UNITED STATES  
NUCLEAR REGULATORY COMMISSION  
WASHINGTON, D. C. 20555

July 8, 1991

SUBJECT: YANKEE ROWE REACTOR VESSEL

### SAFETY ASSESSMENT OF YANKEE ROWE VESSEL

Figure 4 Shift data for  $500 \pm 10^\circ\text{F}$  irradiations versus fluence and preliminary recommended trend curve.

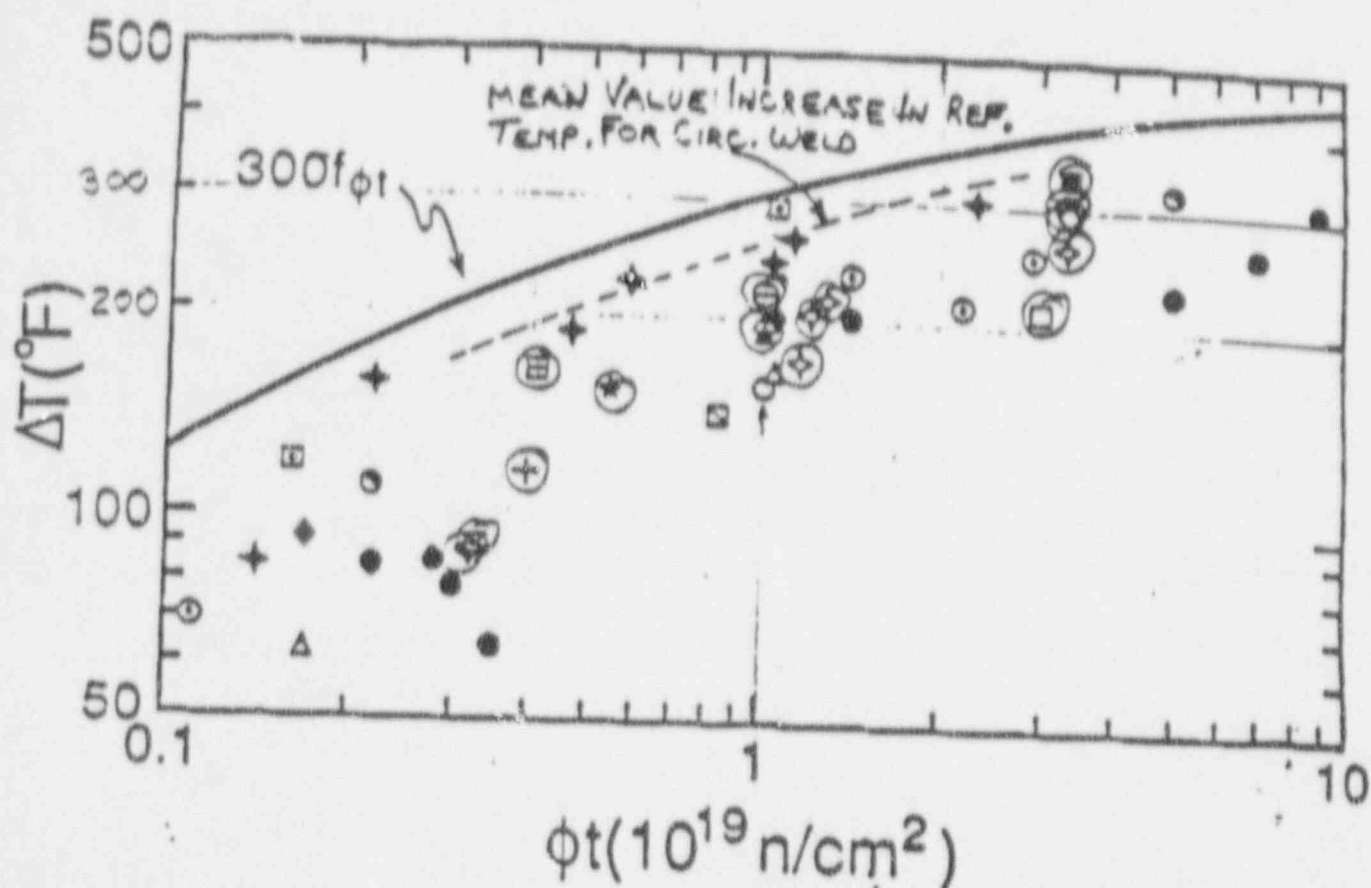
The staff used two bases for estimating  $RT_{NDT}$  for the circumferential weld. One method uses a set of data compiled by Odette (Ref. 4) for 500°F irradiation, which yields a 370°F value for  $RT_{NDT}$ . The other method uses RG 1.99, Rev. 2 methodology, bounding values for copper and nickel, 0.35 percent and 0.70 percent respectively, and 50°F for the irradiation temperature effect. This yields a value of 330°F for  $RT_{NDT}$ . Figure 1 (Figure 4 from Reference 1) reports the increase in reference temperature for weld metals and base metals (plates) at irradiation temperature of 500°F. The dashed line has been added to represent the increase in reference temperature for the circumferential weld using the RG 1.99, Rev. 2 bounding method with 50°F correction for the irradiation temperature effect. Since this curve bounds all the existing weld data in the Odette report, this method has been used to estimate values of reference temperatures for the circumferential and axial weld metal where the amount of copper is unknown and the weld metal is subject to 500°F irradiation temperature.
